From: Fowler, Samuel W. <sfowler@nacintl.com>
Sent: Monday, December 04, 2017 9:30 AM
To: White, Bernard
Cc: Carver, George; Chapman, Deborah R.; Baldner, Heath M.
Subject: [External_Sender] MAGT Shielding Tolerance

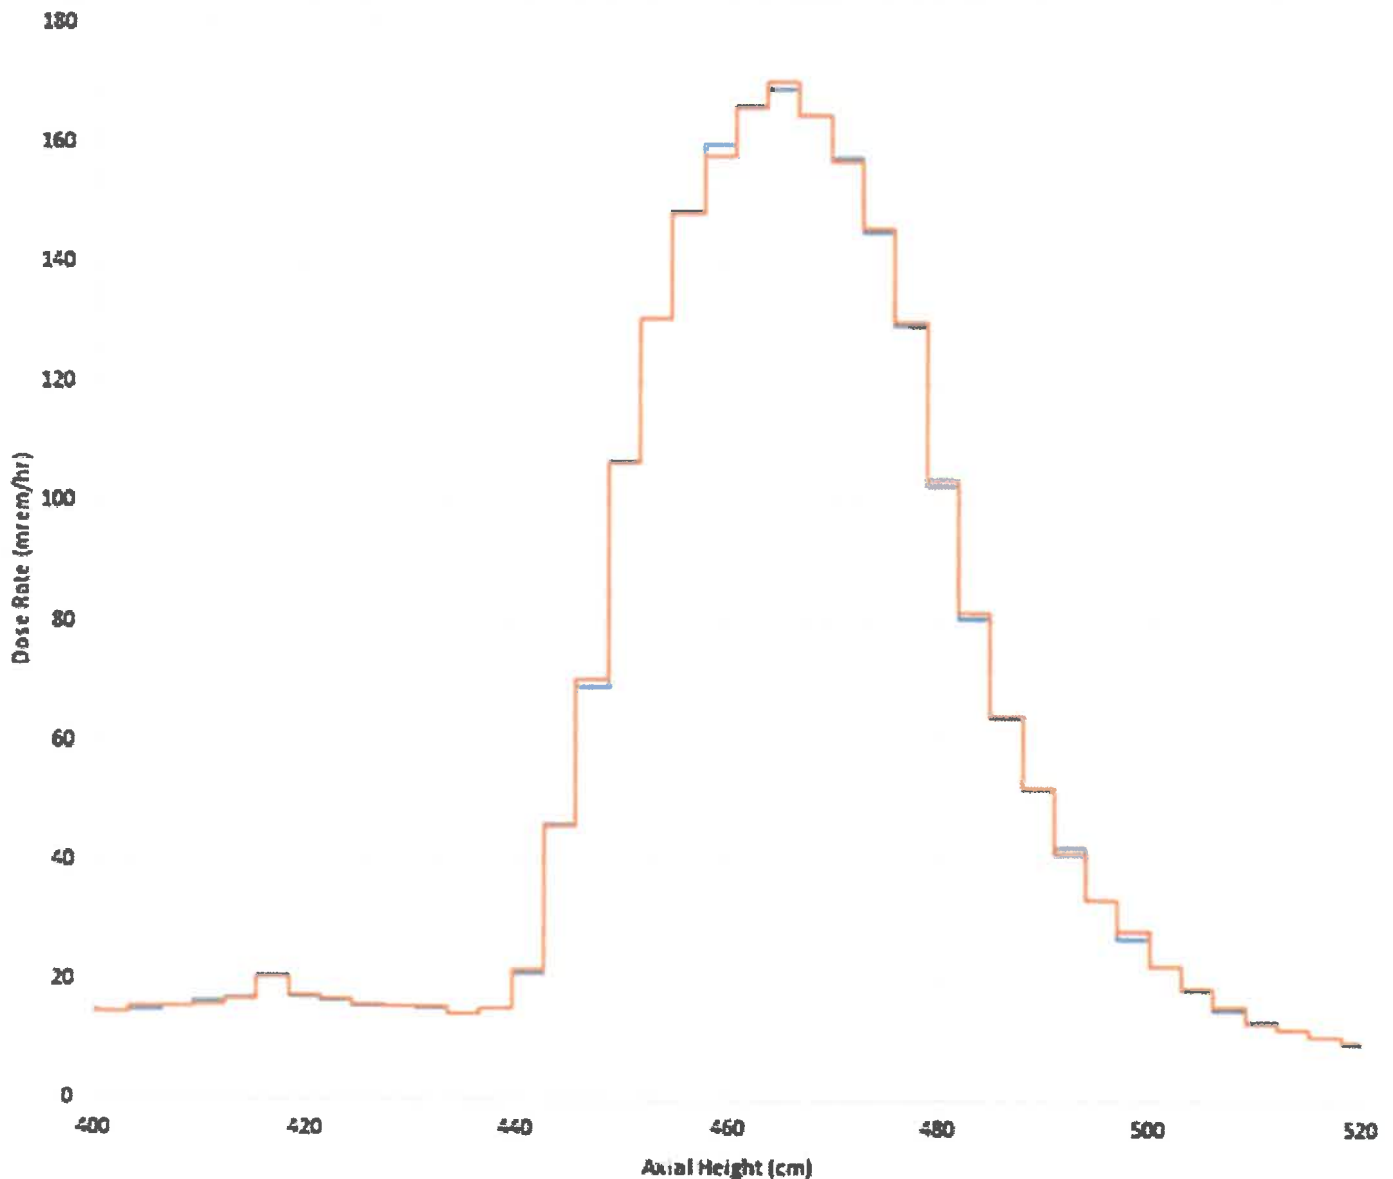
We reran the shielding evaluation with the lead being 0.06-0.09 inches lower (i.e., further from the lid). Below is the surface plot. As you can see, it resulted in a minor shift in the dose rate curve but negligible impact on total dose rate.
